GROUP	MODEL
Voluntary Emissions Service Campaign	2024MY Multiple Models
NUMBER	DATE
SC320 (Rev 1, 11/19/2025)	October 2024

EGR VALVE ASSEMBLY REPLACEMENT (SC320)

This bulletin provides information to replace the Exhaust Gas Recirculation (EGR) Valve Assembly on certain 2024MY Kia vehicles listed in the table below. Kia has become aware that the EGR Valve Assembly in the subject vehicles may not have been manufactured to Kia’s specifications. This condition may cause the vehicle to release air pollutants which exceed Federal and California standards. As a result, the subject vehicles may exhibit an illumination of Malfunction Indicator Lamp (MIL) with DTC(s) P040500, P064200 and/or P065200. Follow the procedures outlined in this publication to replace the EGR Valve Assembly. Before conducting the procedure, verify that the vehicle is included in the list of affected VINs.

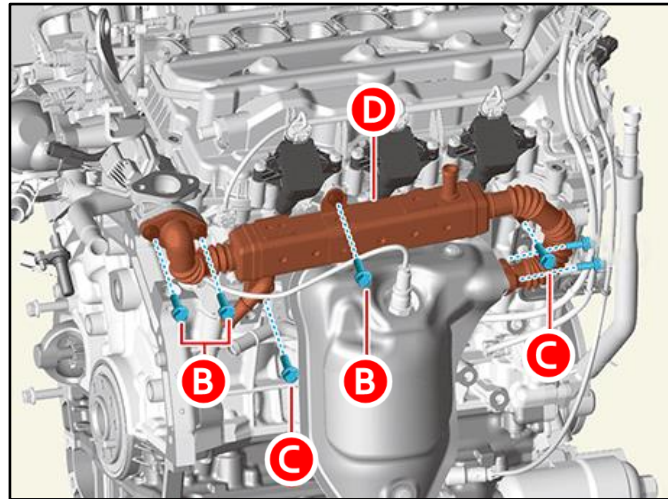
2. Loosen bolts (B) and (C) securing the EGR cooler (D) to gain additional access to the EGR valve assembly by referring to "Intake and Exhaust System → EGR Cooler → Removal" **step 2** in the applicable Shop Manual on KGIS.

Note: The EGR cooler does not need to be removed to gain access to the EGR Valve Assembly.

Tightening torque for EGR Cooler Bolts:
 (B) 13.7 - 17.4 lb.ft (18.6 - 23.5 N.m)
 (C) 36.2 - 39.8 lb.ft (40.0 - 53.9 N.m)

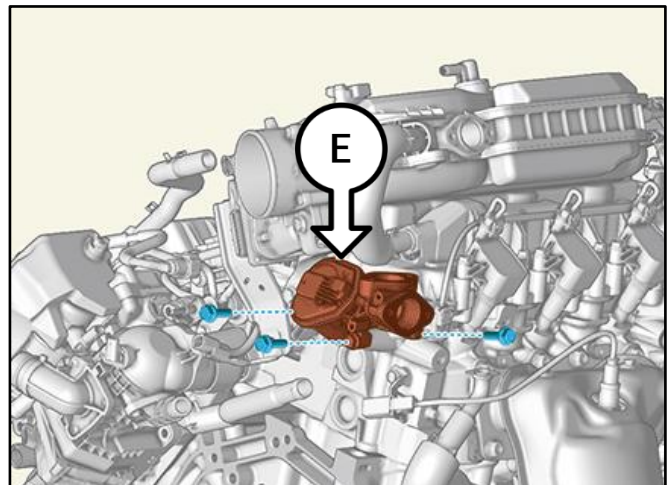
3. Replace the Exhaust Gas Recirculation (EGR) Control Valve (E) by referring to "Emission Control System → Exhaust Emission Control System → EGR (Exhaust Gas Recirculation) → Removal and Installation" in the applicable Shop Manual on KGIS.

Tightening torque for EGR Bolts:
 13.7 - 17.4 lb.ft (18.6 - 23.5 N.m)

EGR VALVE ASSEMBLY REPLACEMENT (SC320)**Replacement Procedure: Sportage (NQ5)**

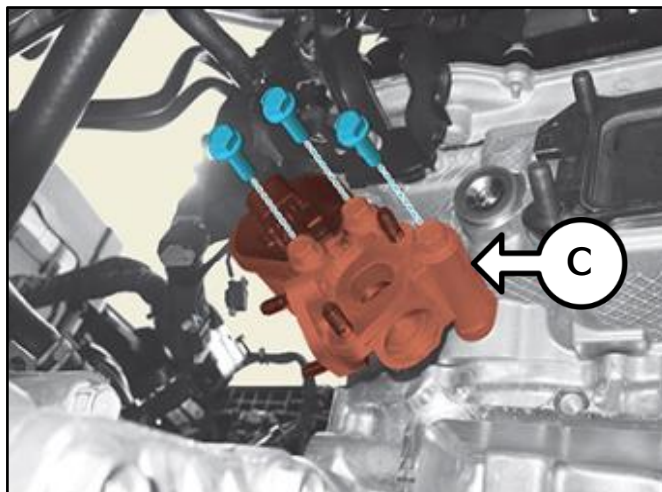
1. Replace the EGR Valve Assembly (C) by referring to "Emission Control System → Exhaust Emission Control System → Electrical Exhaust Gas Recirculation (E-EGR) Control Valve → Removal and Installation" in the applicable Shop Manual on KGIS.

Replacement Procedure: Niro P/HEV (SG2 P/HEV)

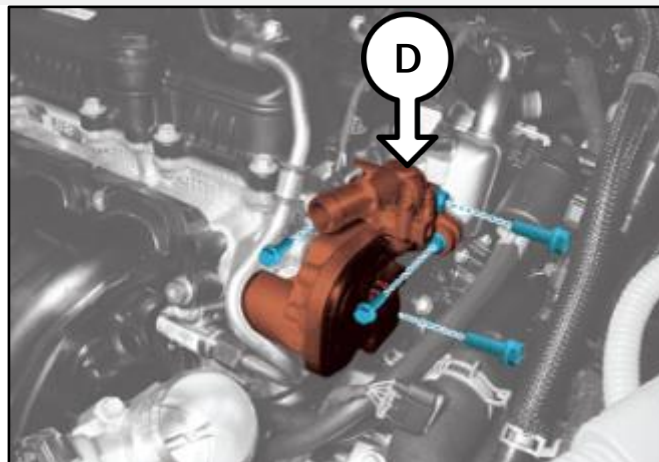
1. Replace the EGR Valve Assembly (D) by referring to "Emission Control System → Exhaust Emission Control System → Electrical Exhaust Gas Recirculation (E-EGR) Control Valve → Removal and Installation" in the applicable Shop Manual on KGIS.
